Item ID: D206-667-101

Item Name: Fwd Crosstube

DRAWING NO. D206-667-141	TITLE CROSSTUBE ASS'Y (206B HIGH FWD)	REV. C	DART AEROSPACE LTD ENGINEERING ORDER		D.E.O. NO. D206-667-141-C-1	SHEET NO. SHEET 1 OF 1	SCALE NTS
DRAWN <i>97</i>	CHECKED <i>ASS</i>	MFG. APPR. <i>18</i>	APPROVED <i>MD</i>		DE APPR. <i>HA</i>		
DATE 11.07.15	DATE 11.07.20	DATE 11.07.21	DATE 11/07/21		DATE 11.07.21

DRAWING NO. D206-667-141	TITLE CROSSTUBE ASS'Y (206B HIGH FWD)	REV. C	DART AEROSPACE LTD ENGINEERING ORDER	D.E.O. NO. D206-667-141-C-2	SHEET NO. SHEET 1 OF 1	SCALE NTS
DRAWN AJS	CHECKED J	MFG. APPR. E	APPROVED AP	DE APPR. H		
DATE 12.08.02	DATE 12.08.02	DATE 12.08.02	DATE 12.08.02	DATE 12.08.02

DETAIL P
BONDING STRAP INSTALLATION 2 PL

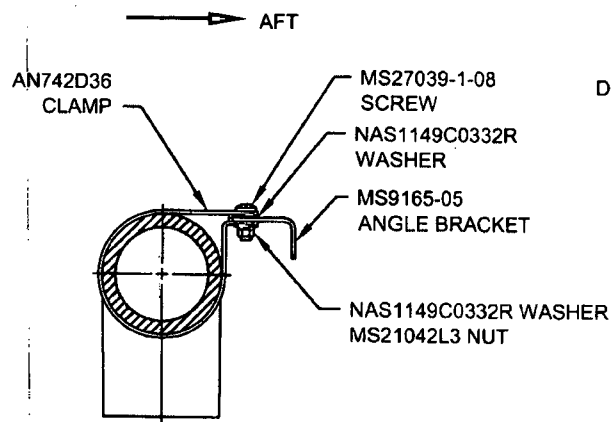
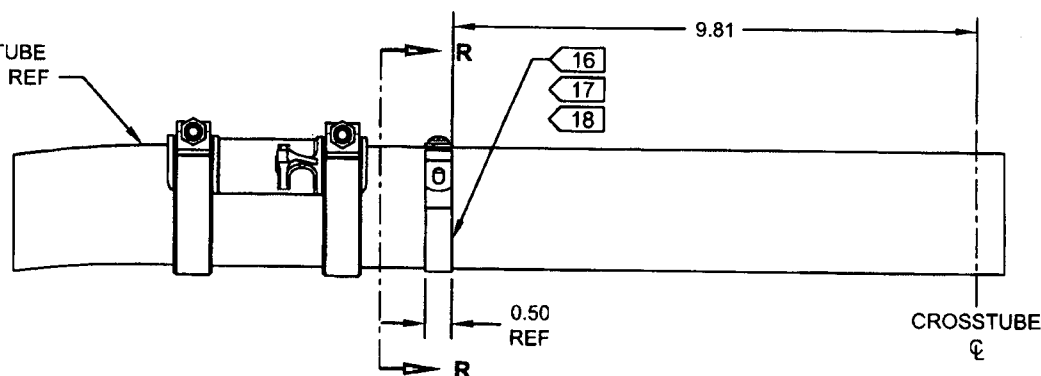
ADD ELECTRICAL GROUNDING STRAP

ADD
